Illinois Department of Transportation

SUBJECT: FAP Route 330(US 45)
Project NHPP-HPP-2081(100)
Section 103R-5
Cook County
Contract No. 60M62
Item No. 116, April 26, 2013 Letting
Addendum A

NOTICE TO PROSPECTIVE BIDDERS:

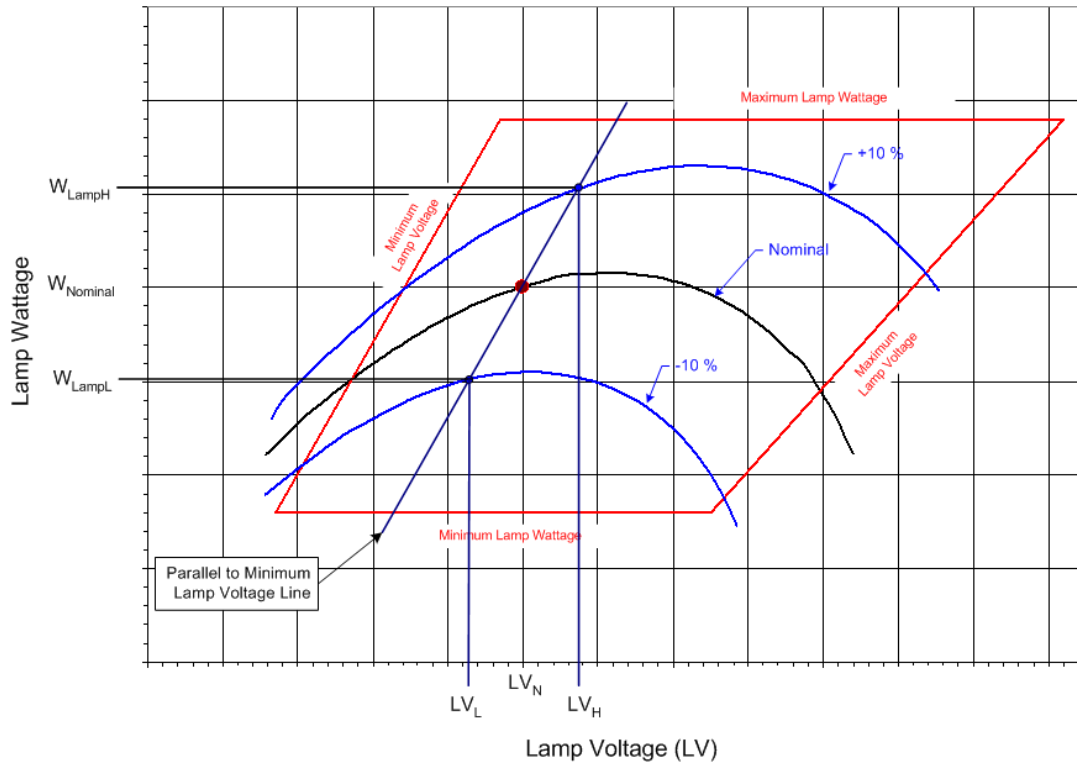
Revise Article 1067(f)(1) of the Standard Specifications to read:

“The high pressure sodium, auto-regulator, lead type (CWA) ballast shall be designed to ANSI Standards and shall be designed and rated for operation on a nominal 240 volt system. The ballast shall provide positive lamp ignition at the input voltage of 216 volts. It shall operate the lamp over a range of input voltages from 216 to 264 volts without damage to the ballast. It shall provide lamp operation within lamp specifications for rated lamp life at input design voltage range. Operating characteristics shall produce output regulation not exceeding the following values:

Nominal Ballast Wattage	Maximum Ballast Regulation
750	25%
400	26%
310	26%
250	26%
150	24%
70	18%

For this measure, regulation shall be defined as the ratio of the lamp watt difference between the upper and lower operating curves to the nominal lamp watts; with the lamp watt difference taken within the ANSI trapezoid at the nominal lamp operating voltage point parallel to the minimum lamp volt line:

$$\text{Ballast Regulation} = \frac{W_{LampH} - W_{LampL}}{W_{LampN}} \times 100$$

Added 4-19-2013

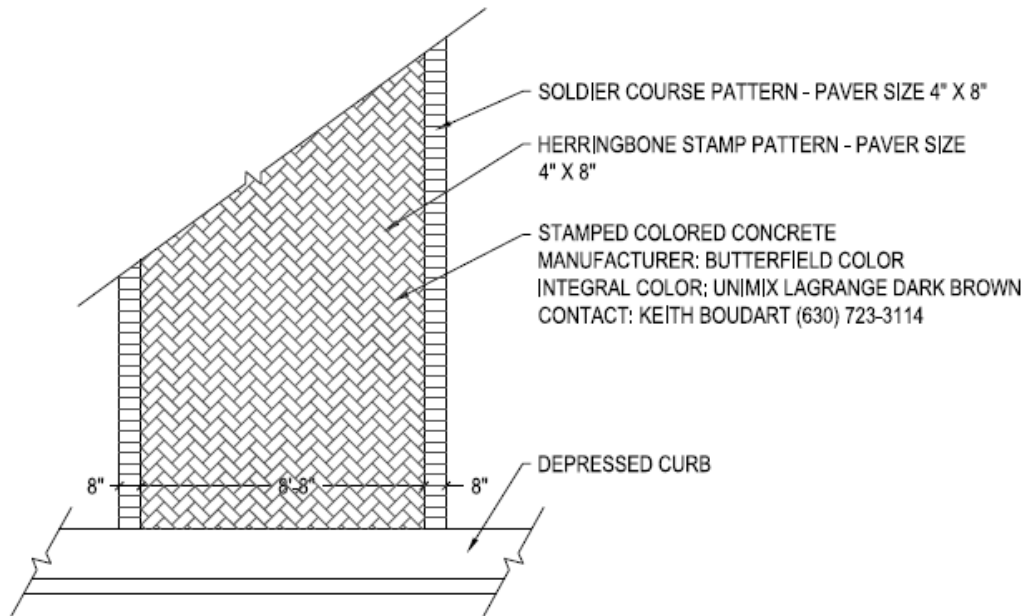
- NOTES:
1. CONTROL AND EXPANSION JOINTS TO ALIGN WITH ROADWAY JOINTS
 2. PROVIDE CONTINUOUS KEY INTO ADJACENT CONCRETE TO PREVENT DIFFERENTIAL SETTLEMENT
 3. REFER TO ENGINEERING PLANS FOR PAVEMENT PROFILE INFORMATION
